**BEFORE THE PUBLIC UTILITIES COMMISSION
OF THE STATE OF SOUTH DAKOTA**

**IN THE MATTER OF THE
APPLICATION BY OTTER TAIL
POWER COMPANY AND WESTERN
MINNESOTA MUNICIPAL POWER
AGENCY FOR A FACILITY PERMIT
FOR A TRANSMISSION FACILITY
AND ASSOCIATED FACILITIES IN
GRANT COUNTY, SOUTH DAKOTA**

*
* **APPLICANTS' RESPONSES TO
STAFF'S FIRST SET OF DATA
REQUESTS TO OTTER TAIL POWER
COMPANY AND WESTERN
MINNESOTA MUNICIPAL POWER
AGENCY**
*
* **EL24-015**
*
*

STUDY AREA CONSTRAINTS

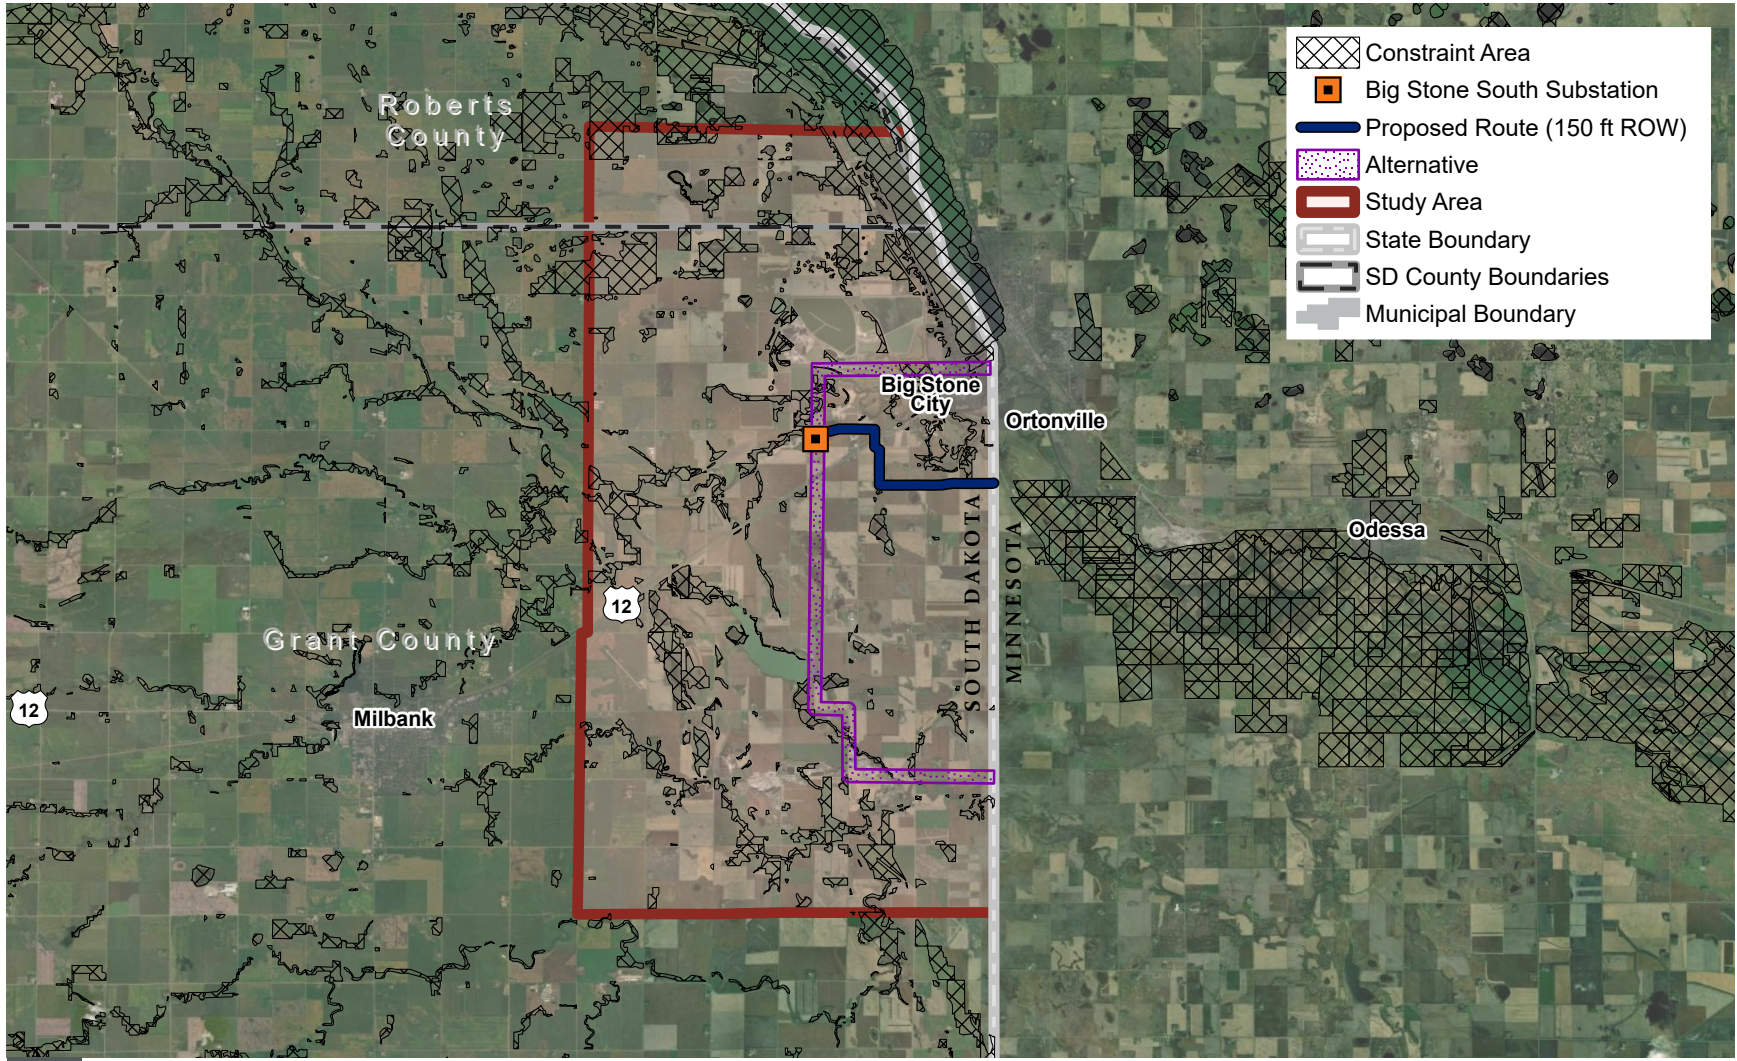
- 1-23) Pursuant to ARSD 20:10:22:35(3), please provide the proposed transmission site and major alternatives as depicted on overhead photographs and land use culture maps.

Jason Weiers: The proposed transmission site and major alternatives are depicted on overhead photographs in Attachment 1 to DR SD-PUC-01.23. The proposed transmission site and major alternatives are depicted on land use culture maps in Attachment 2 to DR SD-PUC-01.23.
